**Statement of Response to ABP's Opinion
in relation to Reg. Ref.: ABP-304838-19**

A Proposed Strategic Housing Development

Newtown, Malahide Road, Dublin 17

Claregrove Developments Limited

Figure 2: Extract from JFA section D-D, which demonstrates the appropriateness of the proposal in the context of the wide expanse of the Malahide Road to the west

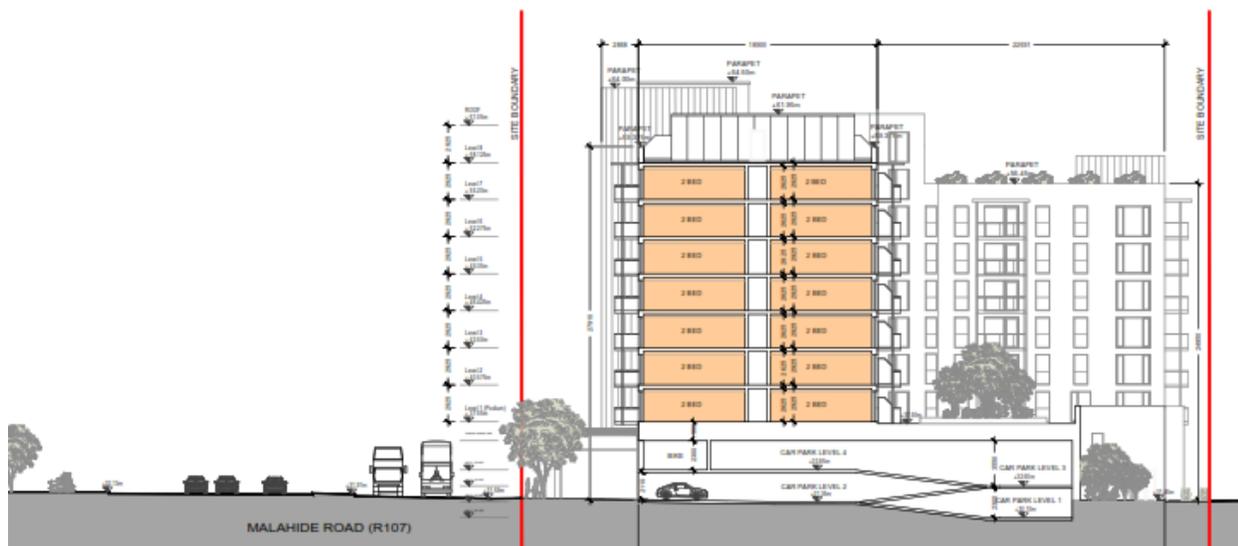
The DCC report also noted that it would be useful to receive an east-west cross section of the proposal in relation to the Malahide Road – this has been included as part of the final application drawing pack. It is considered that the cross section serves to confirm and clearly illustrate that the development provides for an appropriate proportional height to the adjoining road. Future development opposite the subject site (as alluded to in the DCC report on the pre-application stage) will further enhance this streetscape, providing for more appropriate enclosure on both sides in conjunction with the current proposal. We understand that the masterplan for these lands to the west, known as Belcamp, will be put on display shortly and should demonstrate that a similar scale of development is envisaged by DCC.

The final scheme submitted to the Board presents a carefully modulated frontage to Malahide Road, on which the subject site has a prominent location. The design of the two proposed new buildings has been carefully considered both in terms of its overall impression (including scale, massing and steps in building height) and in terms of the finer grain and detailed design of the building frontages, including the rhythm of windows and balconies, and the use of high quality feature materials and treatments (which include patterned brick reveal insets, good quality metal cladding elements, and a distinctive red brick façade treatment). The public open space area
